SAN PEDRO DRIVE N.E. Storm Drain

SS-17-74 REV. 5
SH. 1 of 3

613-75	Added sheet 2, details of headwall & apron		
NO.	DATE	REMARKS	RECORDED BY
REVISIONS			
CITY OF ALBUQUERQUE PUBLIC WORKS DEPARTMENT ENGINEERING DIVISION			
TITLE Details of headwall for 54" S.S. in San Pedro Blvd. @ drainage channel			
DESIGNED BY <i>Curt</i>	DRAWN BY <i>E. Emmett</i>	AS BUILT	
TITLE <i>Draftsman</i>	TITLE <i>Draftsman</i>	CREATED BY	
DATE <i>6/18/75</i>	DATE <i>6/18/75</i>	DATE	
APPROVAL			
ASS'T CITY ENGINEER <i>[Signature]</i>	CITY ENGINEER <i>[Signature]</i>	RECORDED BY	
DATE <i>25 Jun 75</i>	DATE <i>25 Jun 75</i>	TITLE	
WATER ENGINEER	LIQUID WASTE ENGINEER	DATE	
DATE	DATE	SHEET NO. <i>2</i> OF <i>2</i>	
DRAWING NUMBER	55-17-74	REV. 5

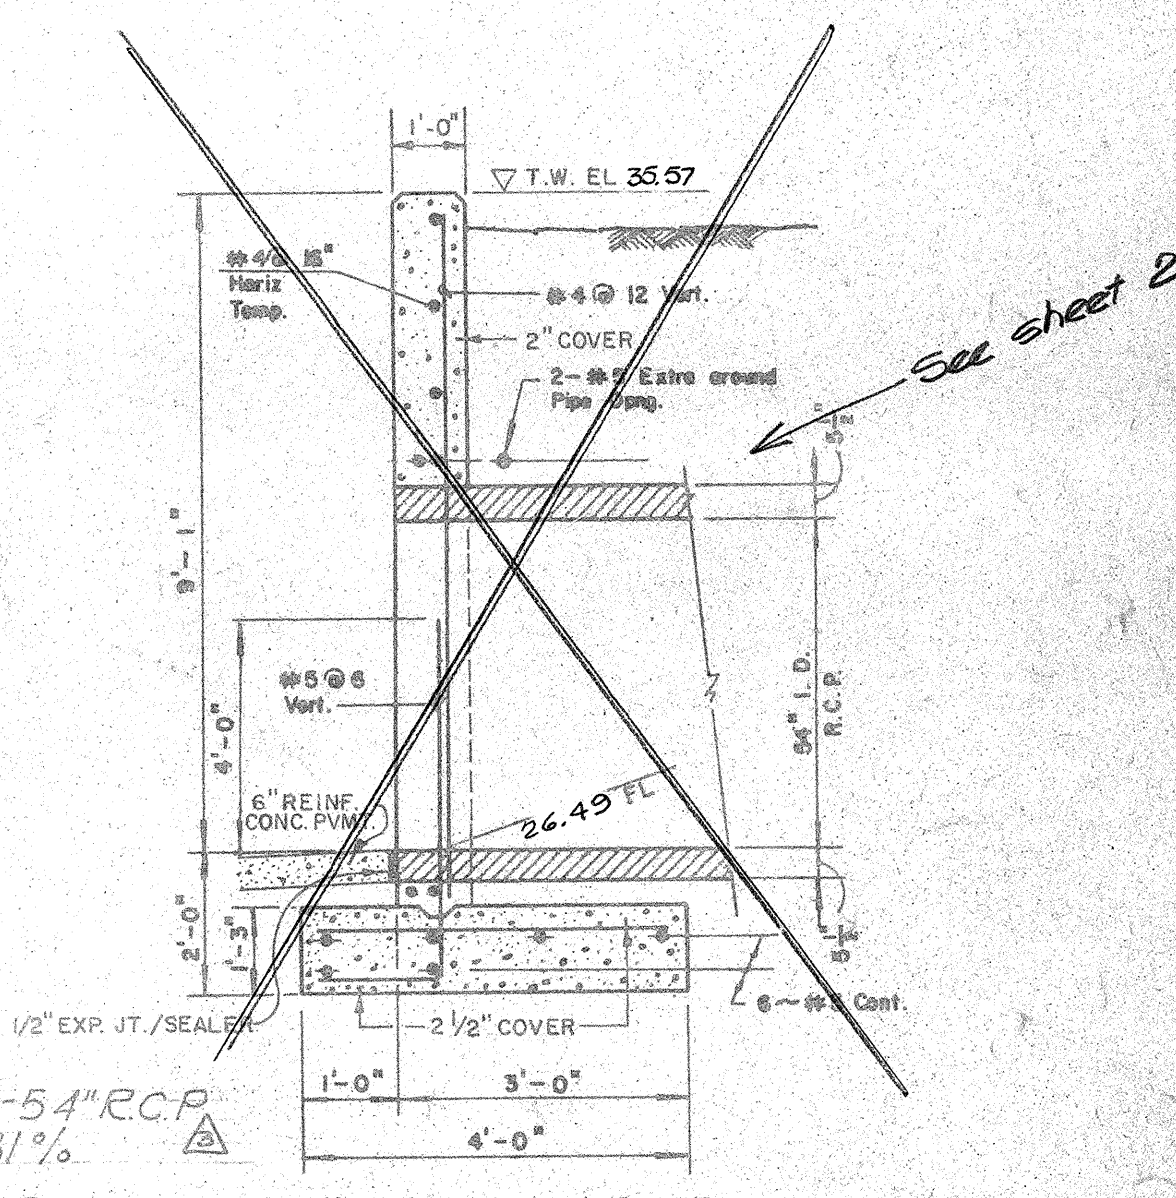
Remove existing Conc. and Construct new 6" Conc. Apron reinforced per original design.

See Revision 5, sheet 2, for revised outlet structure

Remove existing A.C. Pavement and replace with 6" Concrete Slab reinforced of W.W.F., 6"x6"/6-6

Remove exist. 68.23'-54" R.C.P. & install on new alignment as shown. Existing C.B. See sheet CA/U-1

NO	DATE	REVISIONS
1	8/29/74	Relocate exist. Water line & Gen. Notes added F.L. Rev.
2	9/23/74	54" S.D. FL. revised
3	5-7-75	Rev. location of 54" R.C.P. & reconstruct Part of Exist. Conc. Apron
4	6-5-75	Lower Re-Align
5	6-13-75	Lower 54" R.C.P. and conc. apron Added sheet 2
